Entergy Nuclear Northeast  
Indian Point Energy Center  
450 Broadway, GSB  
P.O. Box 249  
Buchanan, NY 10511-0249  
Tel 914 734 6700

Re: Indian Point Unit 3  
Docket No. 50-286  
NL-04-156

**Subject: Reply to RAI Regarding Indian Point 3 Stretch Power Uprate dated  
November 5, 2004 (TAC MC 3552)**

Figure RSA-8-1 RCSL Figure from Draft IP3 Cycle 14 COLR

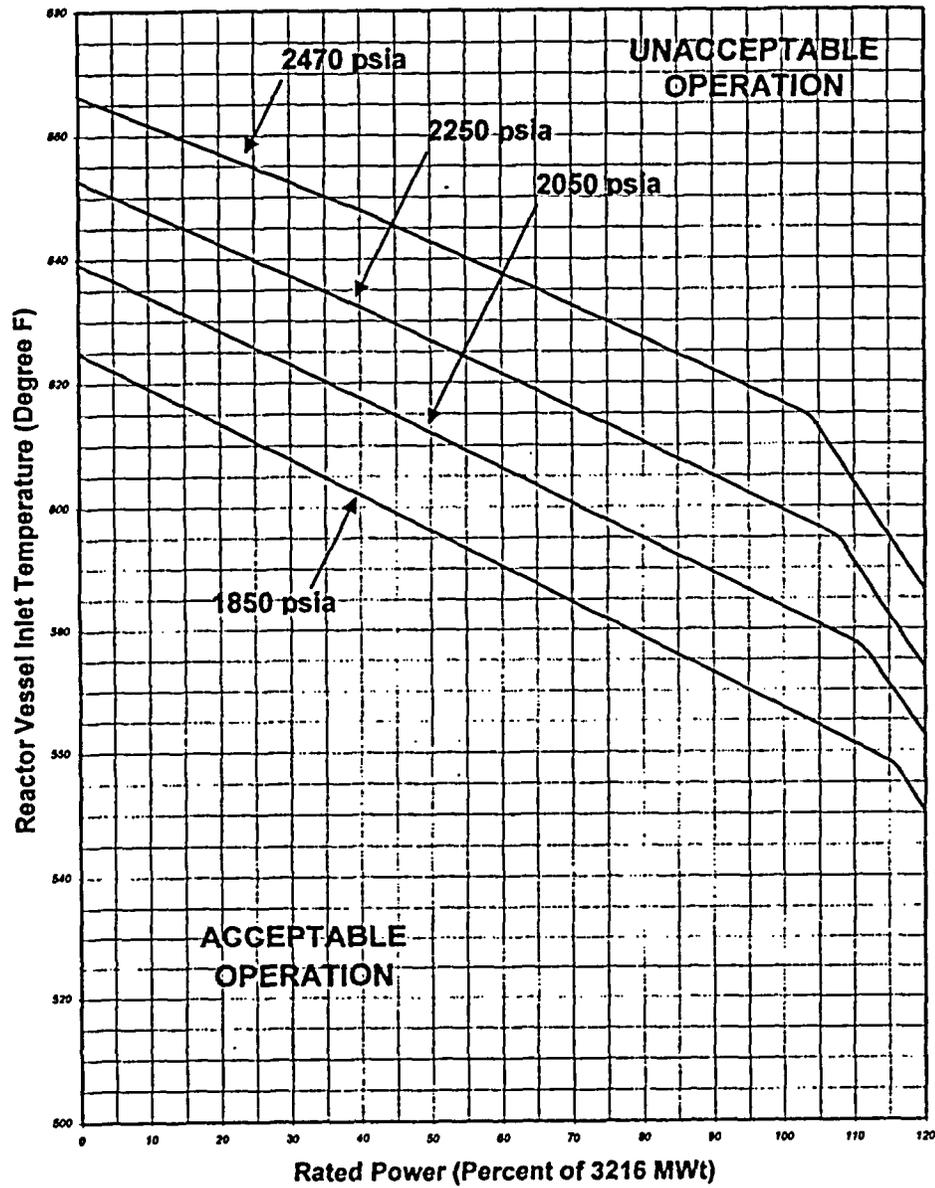
Many cycle-specific parameters have been relocated to the core operating limits report (COLR), which was not submitted with the application. These include the Reactor Core Safety Limit (RCSL) figure, the values of the constants in the Over-temperature and Over-power  $\Delta T$  functions, respectively (Notes 1 and 2 in Table 3.3.1 1), and the limit values of the pressurizer pressure, RCS average temperature, and RCS total flow rate (limiting condition for operation (LCO) 3.4.1).

Provide the RCSL figure and the values of the constants of the OT $\Delta T$  and OP $\Delta T$  functions, and the RCS flow, average temperature and pressure limit values in the COLR, or confirm that they are the same as those provided in the application report.

A response to this question (except for the RCSL figure) was provided in letter NL-04-145 of November 18, 2004, in Attachment 2 in response to IP2 item NL-04-073-RSA-20. That response is provided below. The RCSL figure is provided as Figure 6.3-1 of WCAP-16212-P and WCAP-16212-NP and here as Figure RSA-8-1.

Figure 1

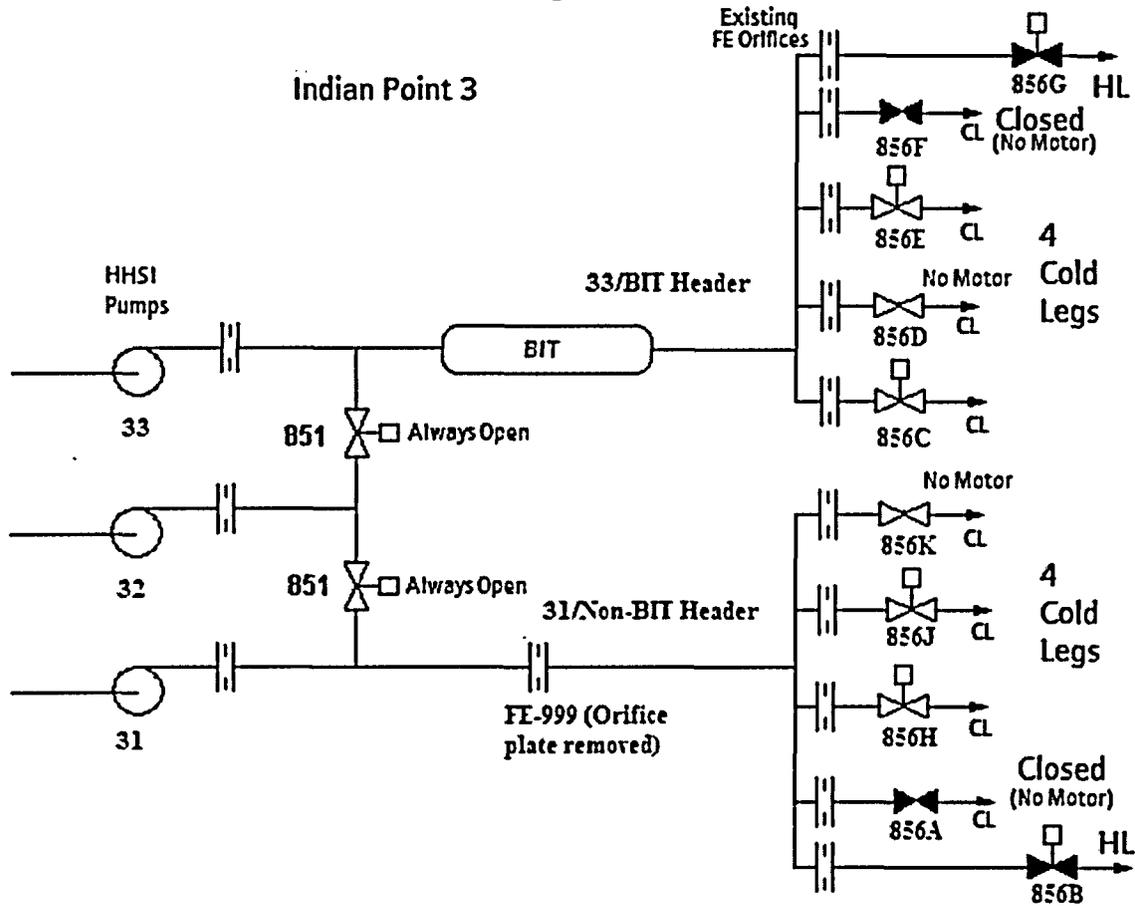
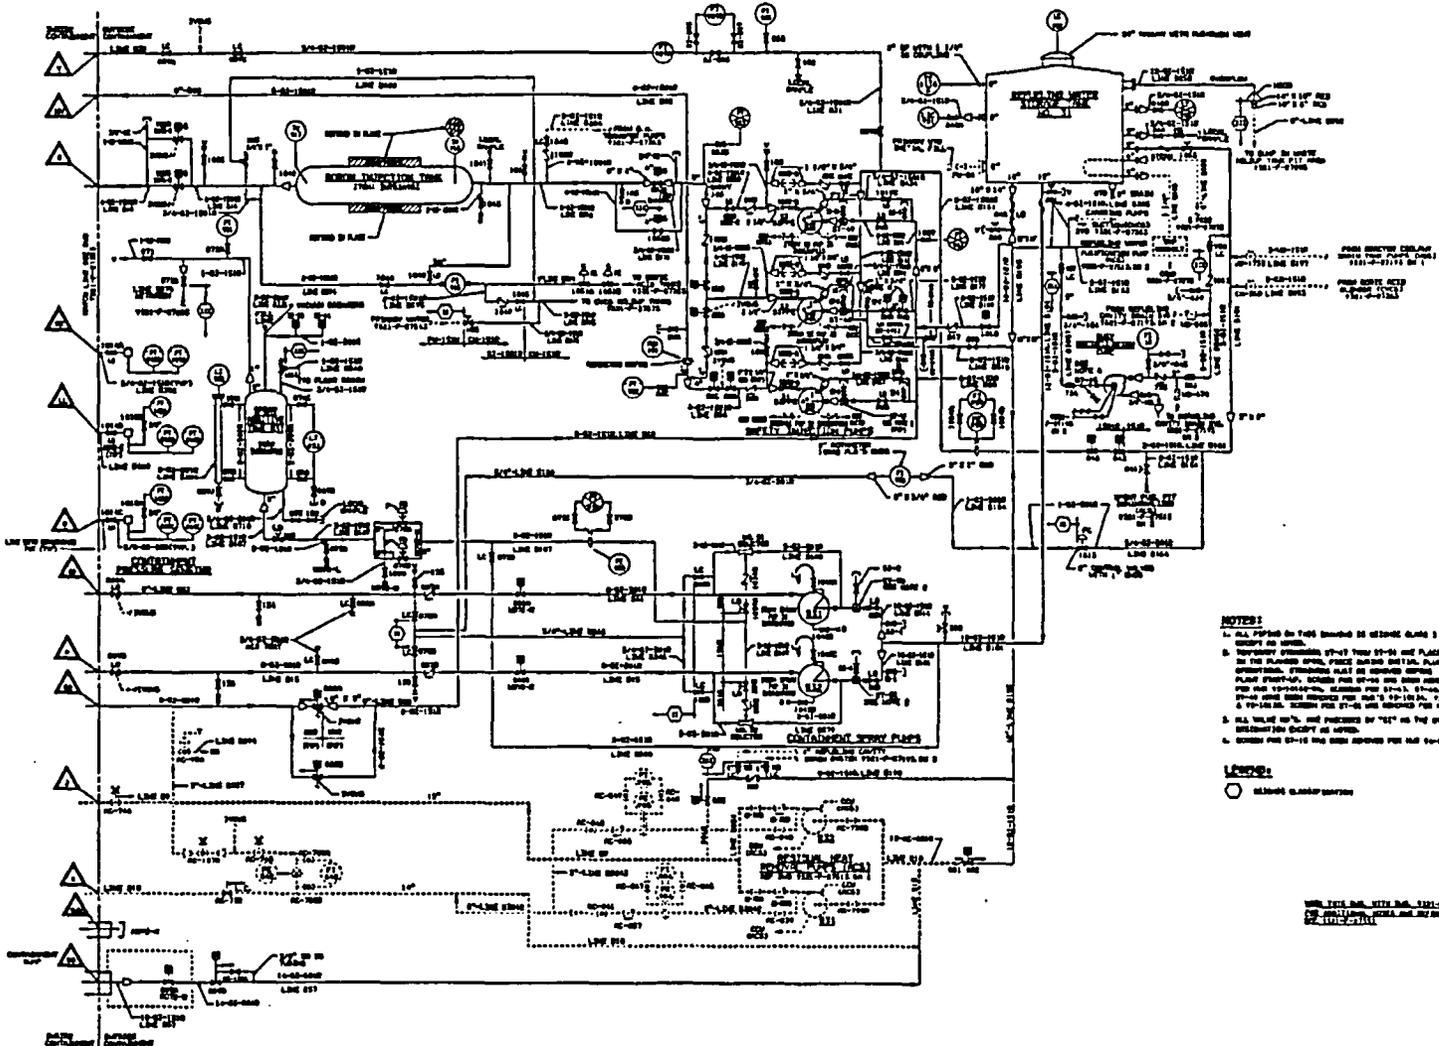
In Section 4.1.4 on the safety injection system/containment spray system of application report, the licensee states the high-head safety injection (HHSI) system was modified by permanently closing two cold leg branch lines, and throttling the HHSI system to provide higher cold leg and hot leg flows. What is the design function of the branch line? Why is it acceptable to defeat this

function permanently? Provide a system diagram which depicts the branch lines that were closed. Discuss how this is administratively controlled and how the redundancy and independence of the system was preserved.

**Question:** Provide a system diagram which depicts the branch lines that were closed.

Figures 6.2-1A and 6.2-1B are system diagrams provided in the Indian Point 3 UFSAR. A simplified figure of the system, showing the lines that are closed, is provided as Figure RSA-12-1 attached.

The 'permanently' closed valves will be administratively controlled by changing the normal position to locked closed. The valves can be re-opened and subsequently re-closed, as required, during plant shutdown to perform various surveillances on the remainder of the line(s)/components that will remain intact, and connected to the RCS pressure boundary.

As discussed above, revised HHSI system performance (both hot leg and cold leg performance) was calculated with the 856A and 856F manual valves permanently closed. This HHSI flow performance data was then used in the various accident analyses performed in support of the Indian Point 3 SPU program. The appropriate limiting single failures and spilling line assumptions were also applied in calculating the HHSI system flow performance data, including spurious closure of a single cold leg 856 valve as a single active failure. The closure of 856A and 856F valves did not affect the failure analysis described on UFSAR Table 6.2-7, except for the UFSAR page markup shown below.

**Figure SI-1b-1: Probability of Correct Rejection/Reporting (PCR) Considering Only Passed Candidates, Appendix VIII from the Outside Surface. Reporting Criterion A' = 0.15 inch.**

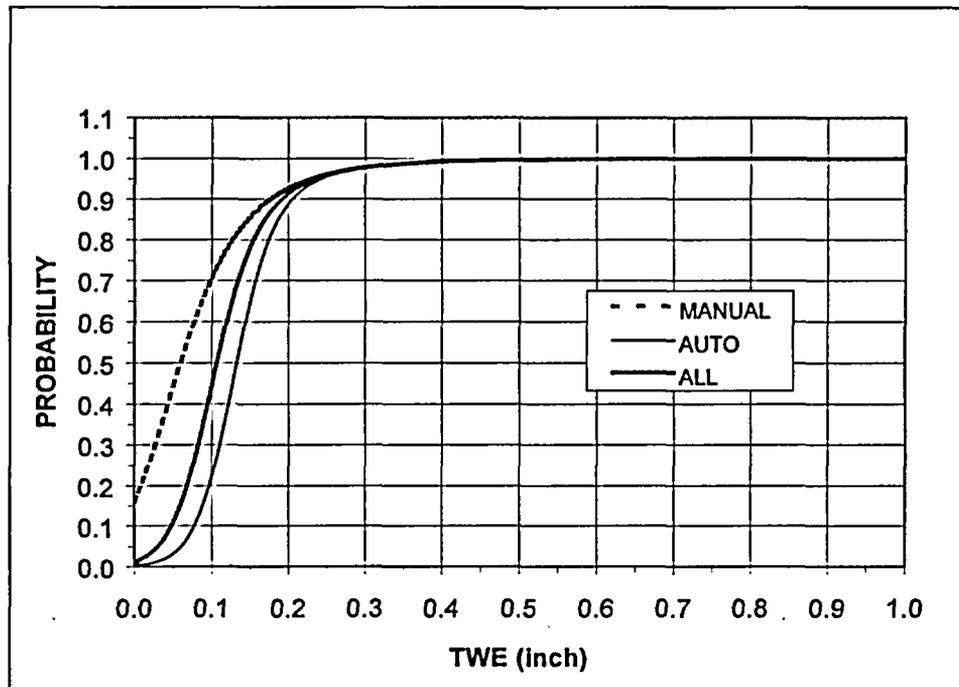
PVM-1 also requested the licensee to justify the use of a smaller flaw size for the RV outlet-nozzle-to-shell region. Table 5.9-4 of the IP3 application report indicates that smaller flaw sizes than those specified in Appendix G of Section XI of the ASME Code were used for the steam generator tubesheet and shell junction, steam outlet nozzle, and feedwater nozzle. Provide a justification for using the smaller size flaw or provide an analysis using the flaw sizes and margins described in Appendix G of the Section XI of the ASME Code.

The PODs for the steam generator tubesheet and shell junction, steam outlet nozzle, and feedwater nozzle can be taken from EPRI Report, "Justification for the Reduction of Inspection Requirements for the Boiling Water Reactor Nozzle-to-Vessel Shell Welds And Nozzle Blend Radii (VIP-108)", R. Carter, June 2002. This report is deemed applicable as the inspection technique would be the same for Steam Generators and applicable for regions with wall-thickness less than 11 inches. As shown in the following figure, the PODs of flaws with depth greater than 0.5-inch is approximately 100% (manual OD volumetric).
